Technical Note TN.JS-005

TITLE

Landing gear travel adjustment

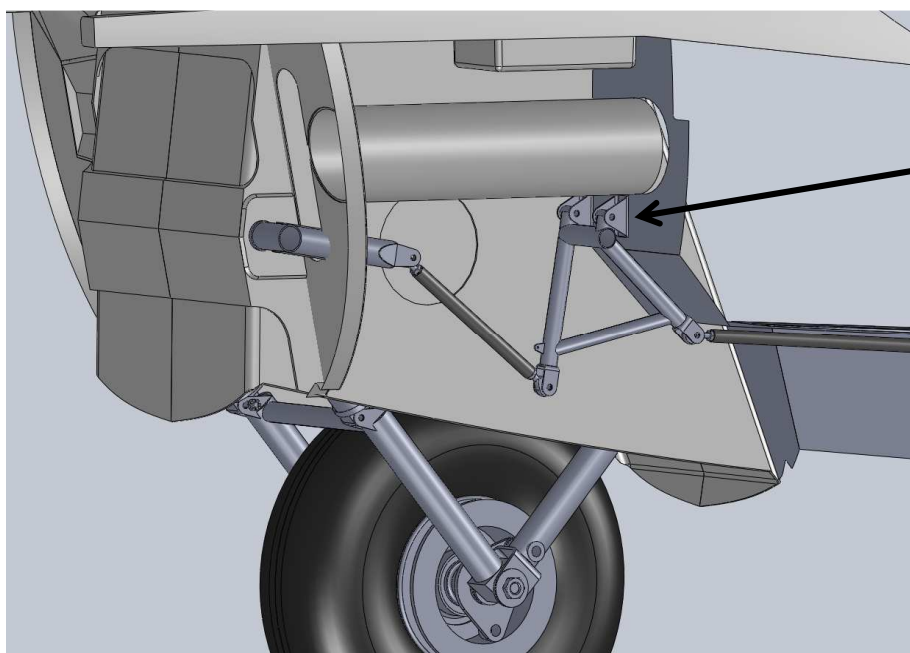
Insert the 10mm glass block spacers between B5 and bell crank mounting brackets on both sides. This will push the bell crank backwards.

5. When all four bolts have been replaced, there will be a gap between the bulkhead and the brackets. Insert the spacers by sliding them in sideways between the bulkhead and the brackets. The spacers must be inserted between the two brackets and slid outwards until seated against the bolts.

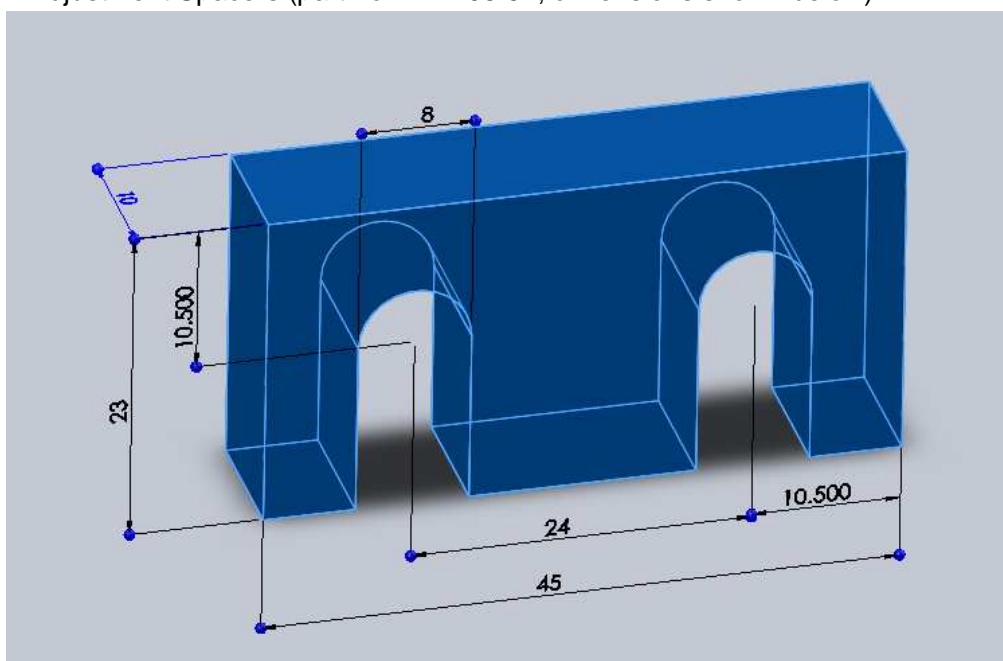
1. 4 M6AB30 SS Dome-headed cap screw bolts (location below oxygen bottle)
2. 2 Adjustment Spacers (part no. 1A-1.05.97; dimensions shown below)
